FAA Implementation of ACR Recommendation 3

Return CAATT Waypoint to Pre-Metroplex location

July 2024

PARQR FOUR ARRIVAL (RNAV)

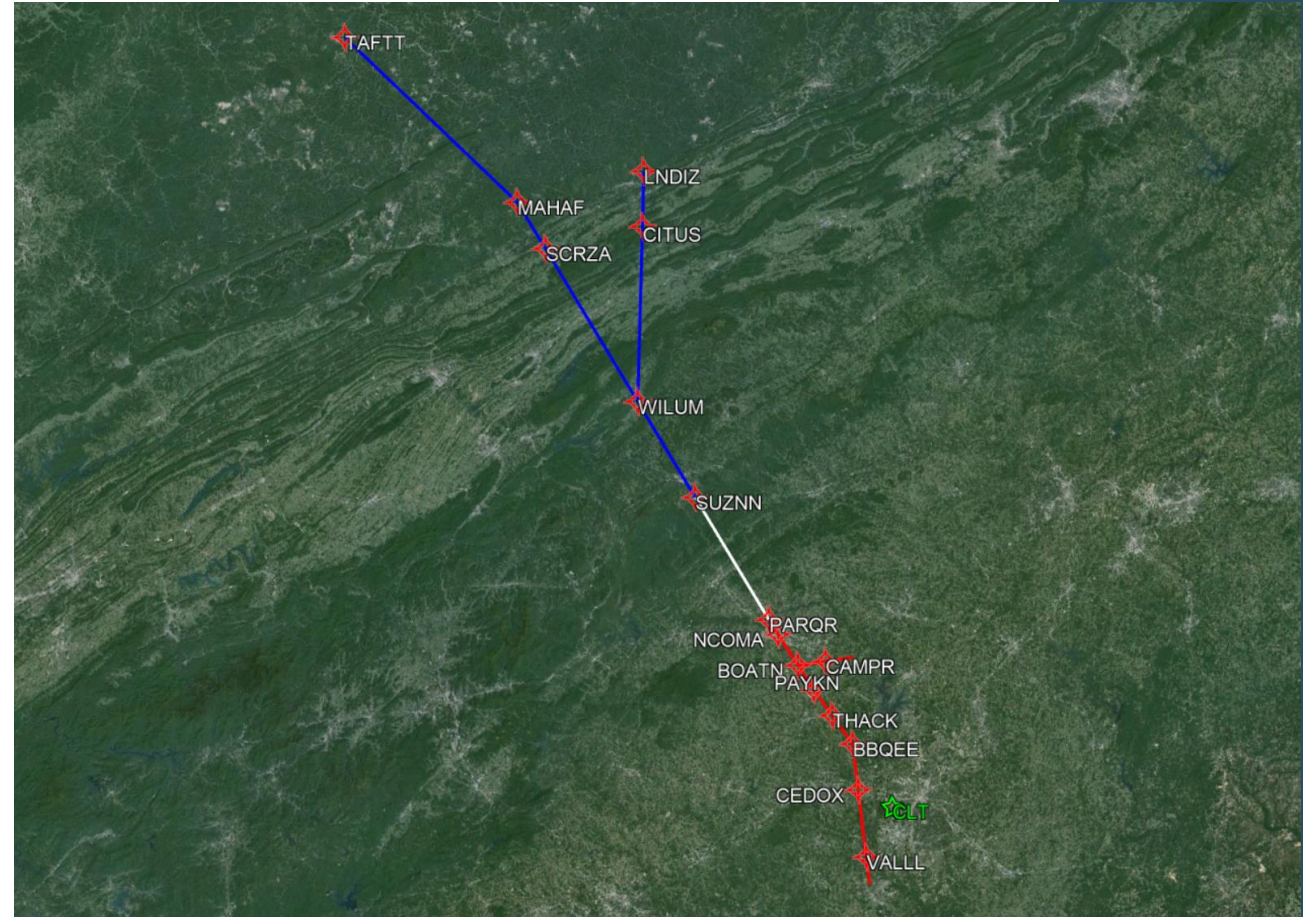
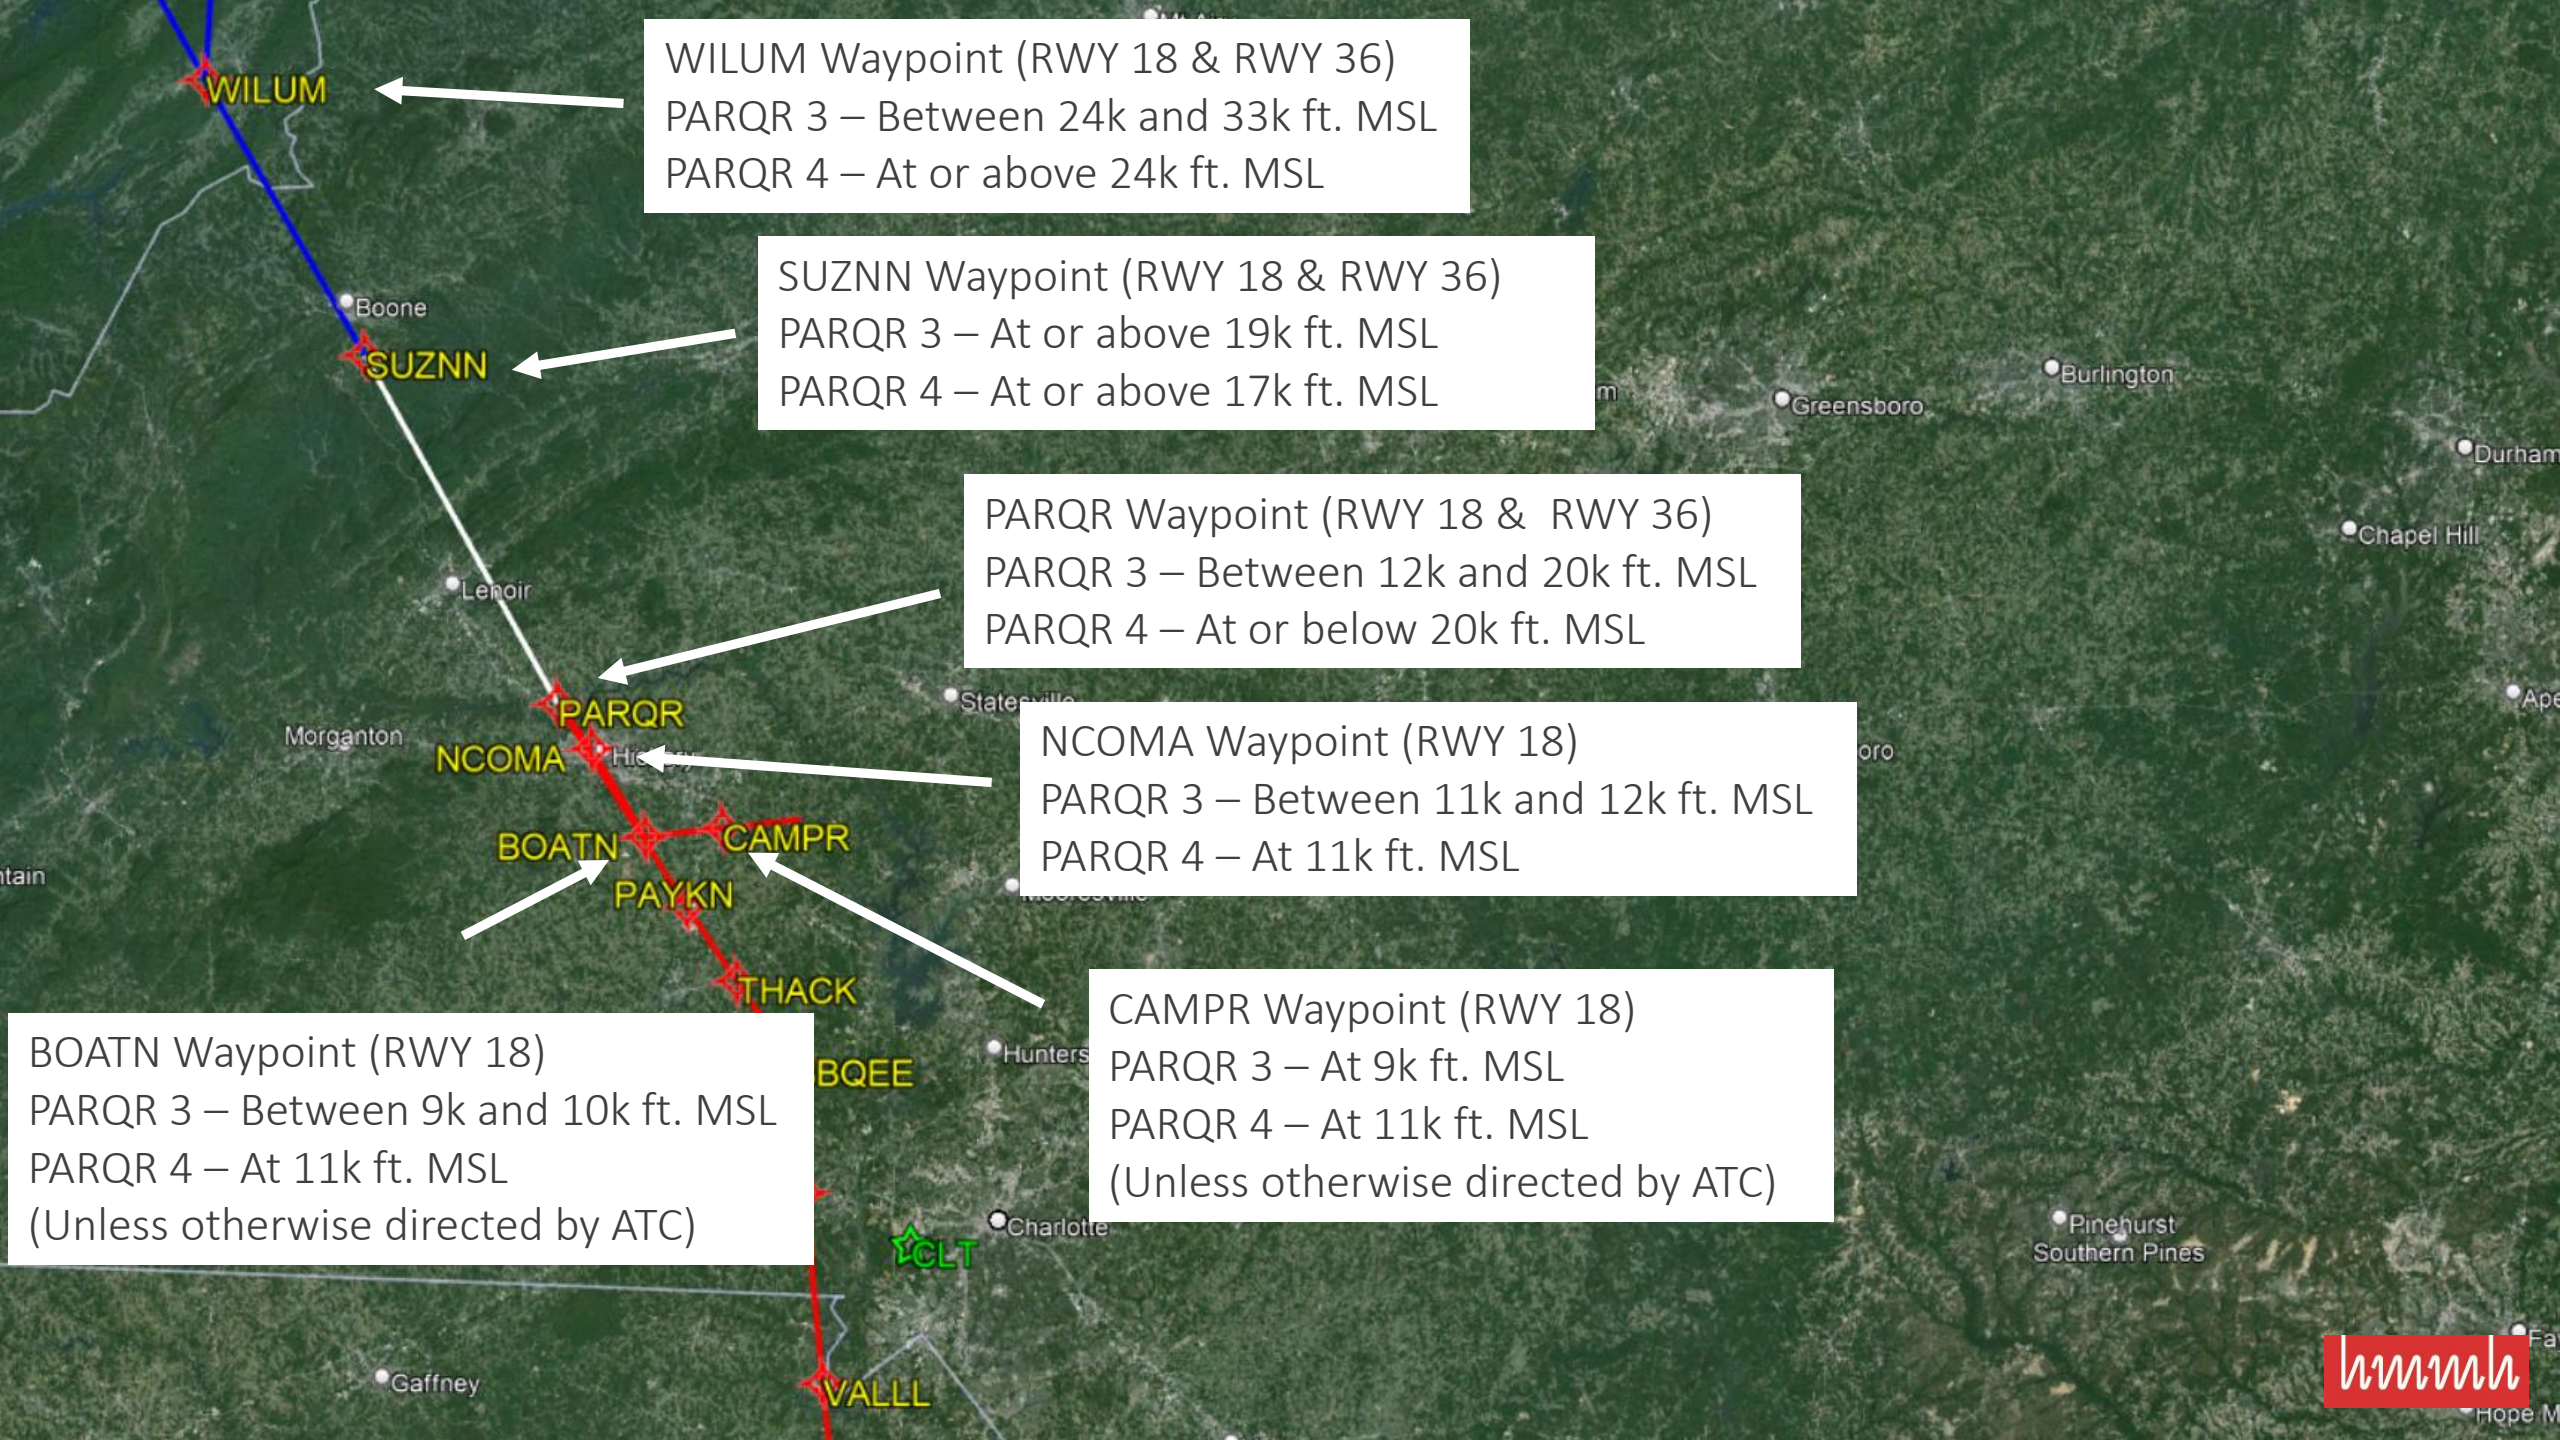
- WILUM – changed altitude restriction to at or above 24k ft. MSL (lower altitude limit remains the same)
- SUZNN – lowered altitude restriction lower limit from 19k to 17k ft. MSL
- PARQR – changed altitude restriction from between 12k and 20k ft. MSL to at or below 20k ft. MSL
- NCOMA – changed altitude restriction from between 11k and 12k ft. MSL to at 11k ft. MSL
- BOATN – removed altitude restriction
- CAMPR – removed altitude restriction

WILUM Waypoint (RWY 18 & RWY 36)
PARQR 3 – Between 24k and 33k ft. MSL
PARQR 4 – At or above 24k ft. MSL

SUZNN Waypoint (RWY 18 & RWY 36)
PARQR 3 – At or above 19k ft. MSL
PARQR 4 – At or above 17k ft. MSL

PARQR Waypoint (RWY 18 & RWY 36)
PARQR 3 – Between 12k and 20k ft. MSL
PARQR 4 – At or below 20k ft. MSL

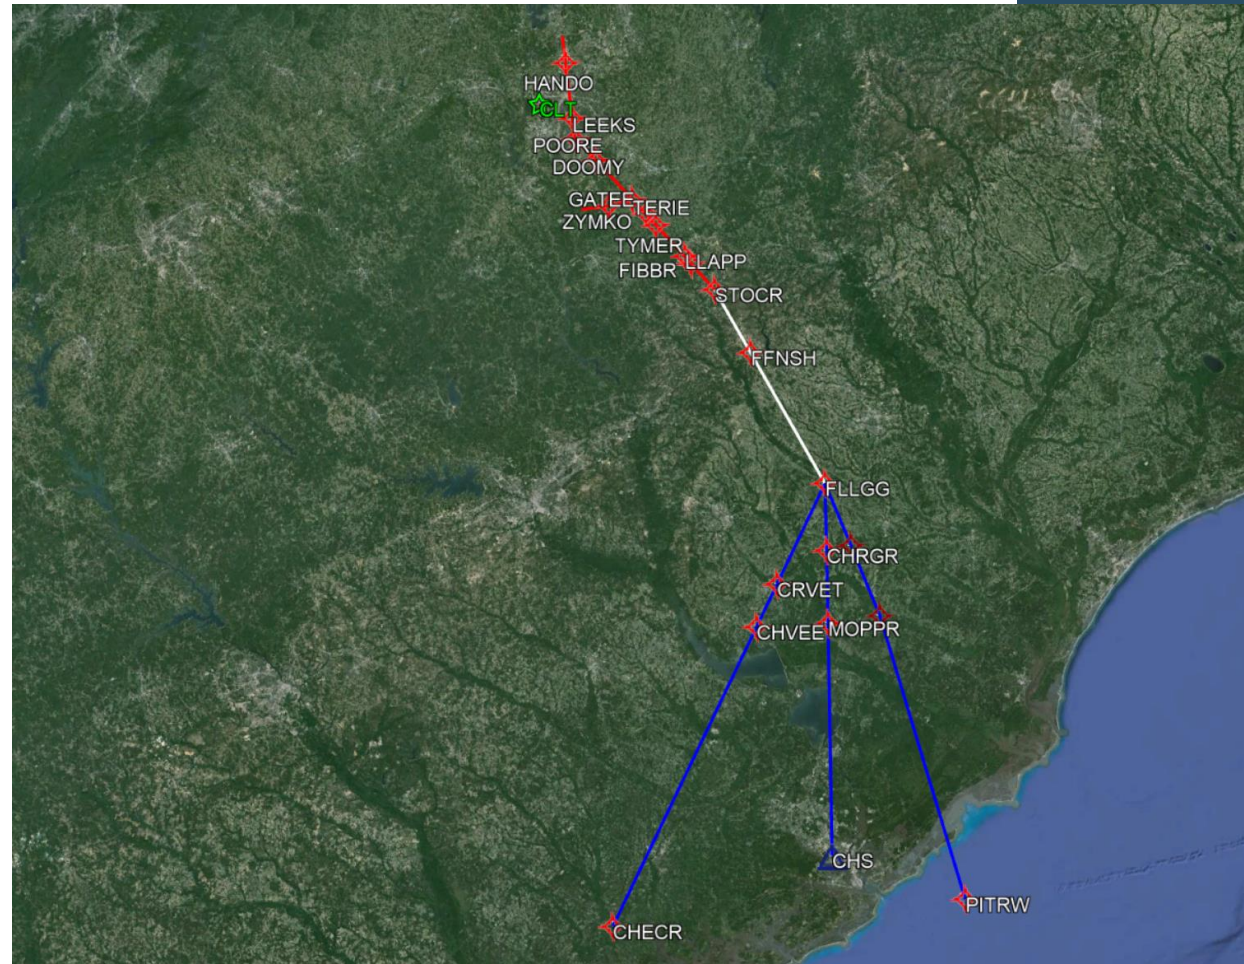
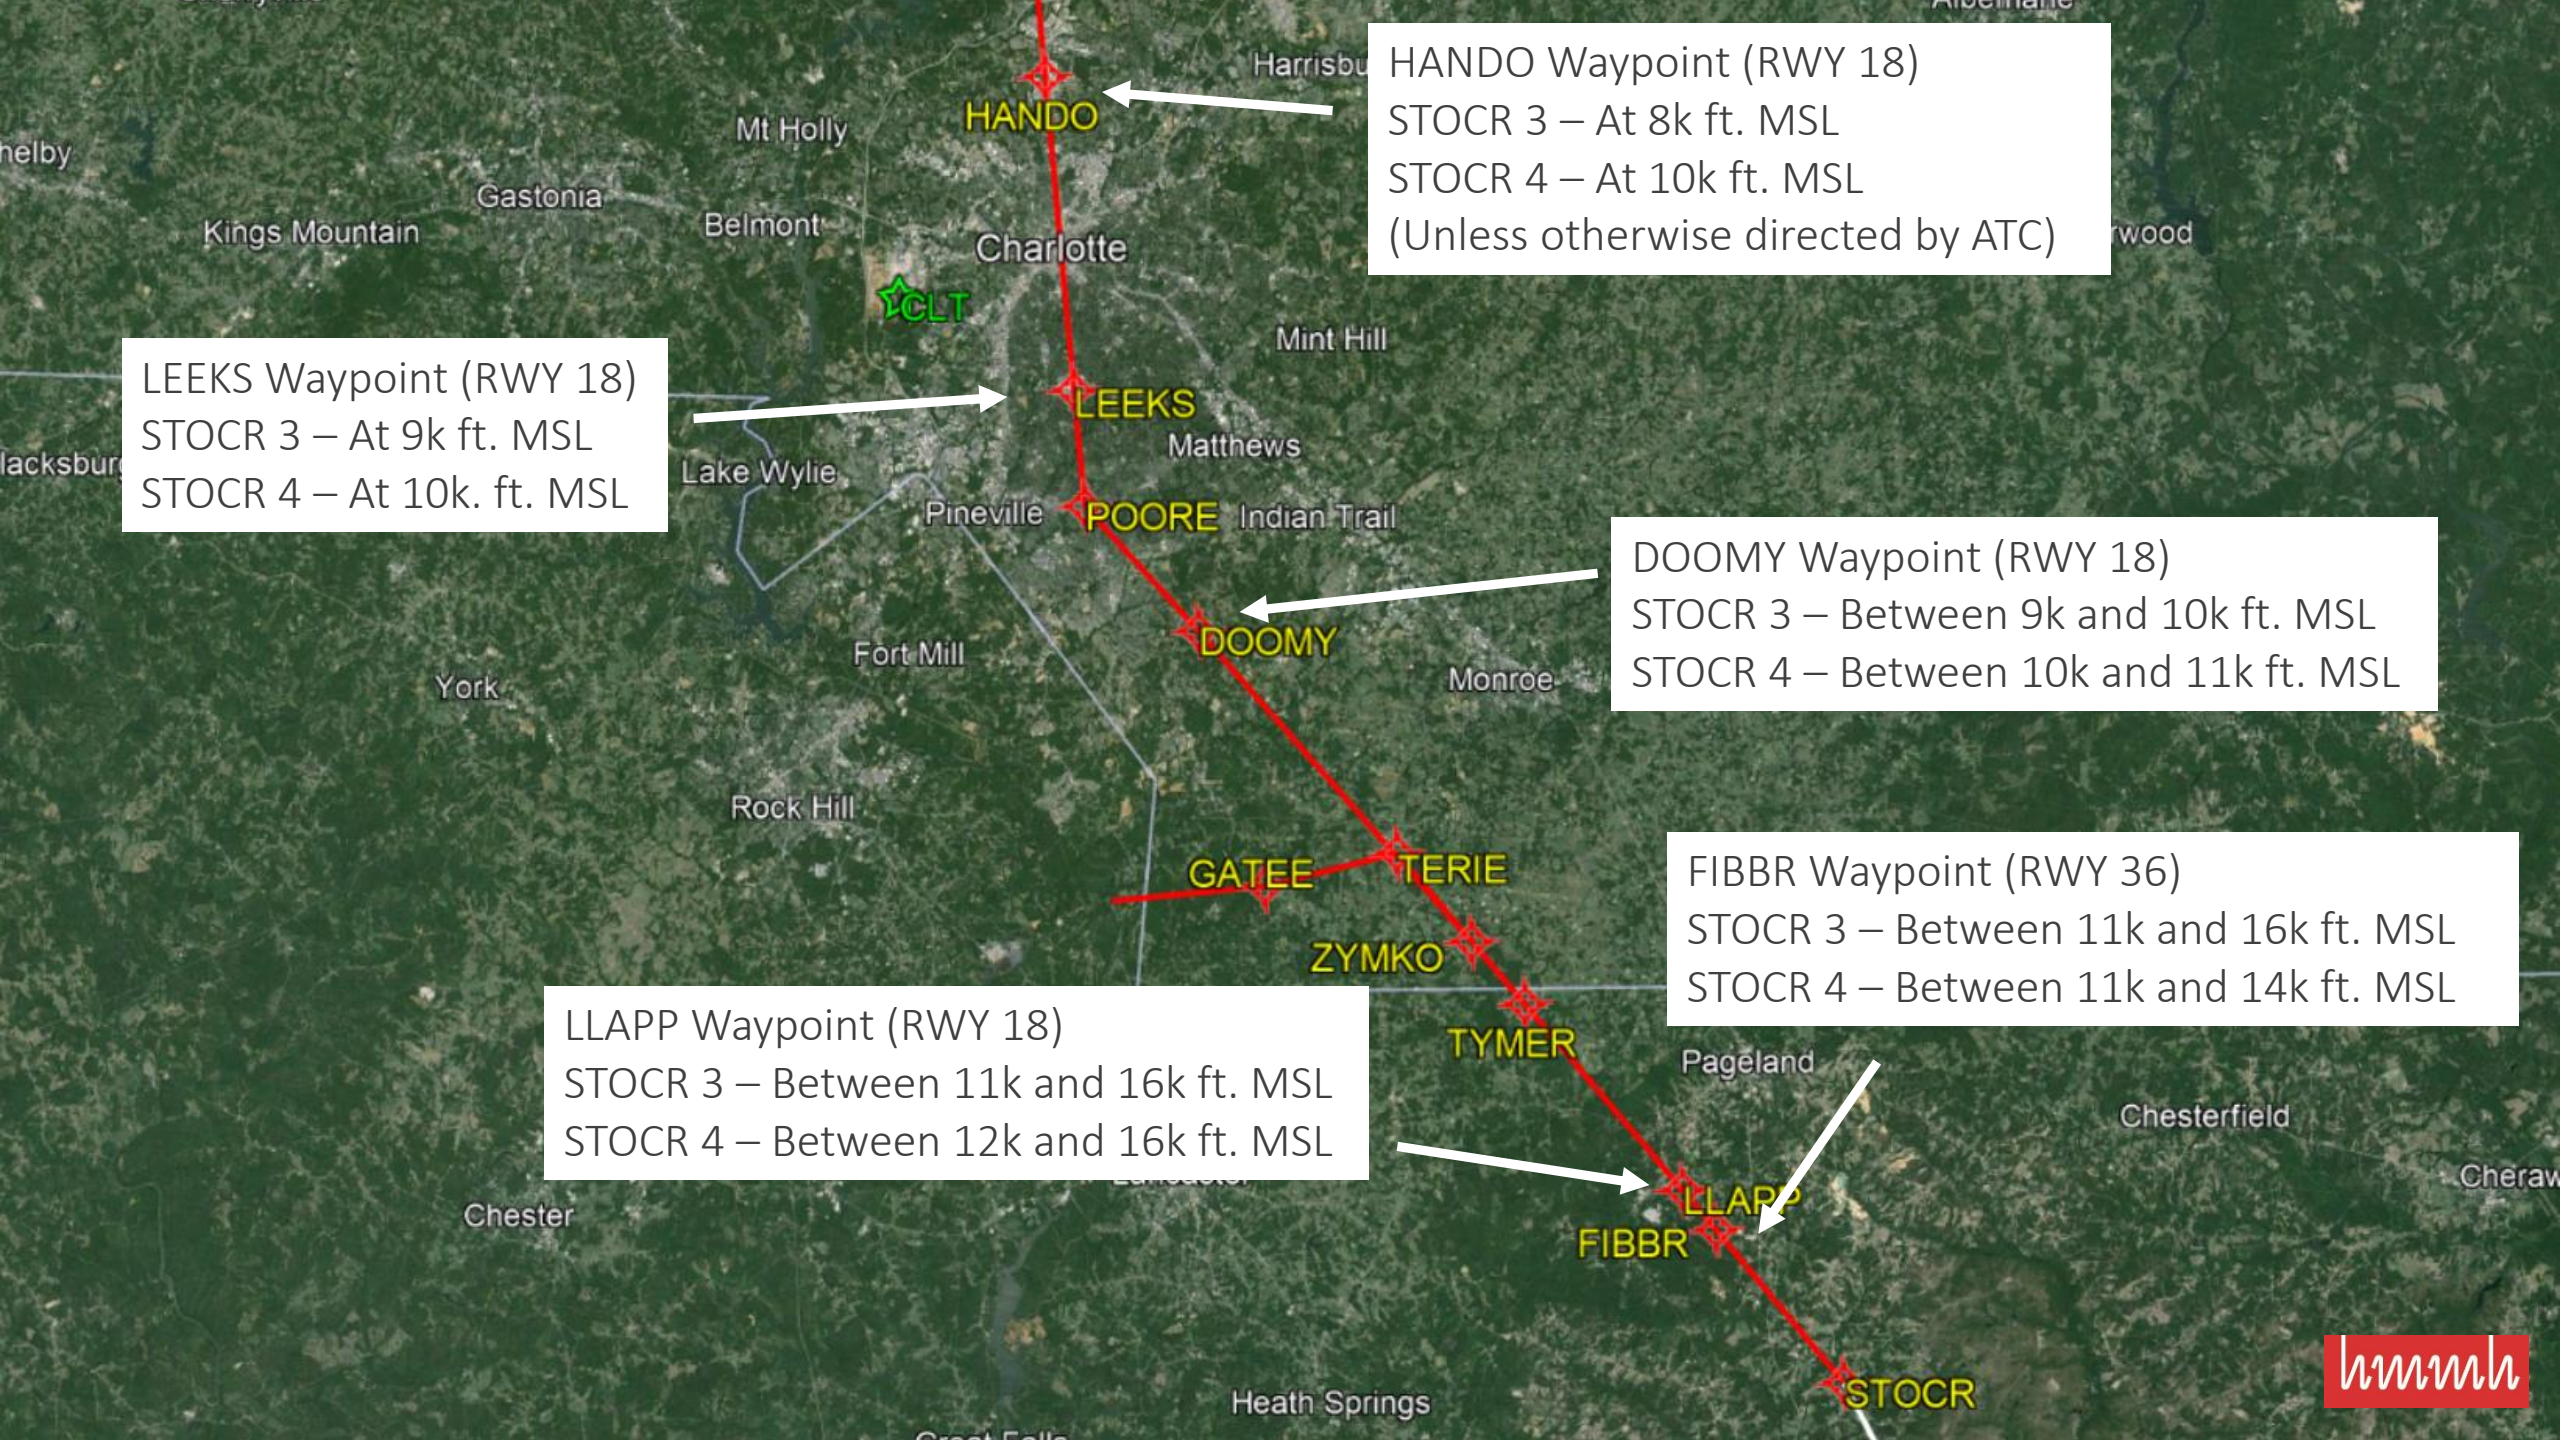
NCOMA Waypoint (RWY 18)
PARQR 3 – Between 11k and 12k ft. MSL
PARQR 4 – At 11k ft. MSL

CAMPR Waypoint (RWY 18)
PARQR 3 – At 9k ft. MSL
PARQR 4 – At 11k ft. MSL
(Unless otherwise directed by ATC)

BOATN Waypoint (RWY 18)
PARQR 3 – Between 9k and 10k ft. MSL
PARQR 4 – At 11k ft. MSL
(Unless otherwise directed by ATC)
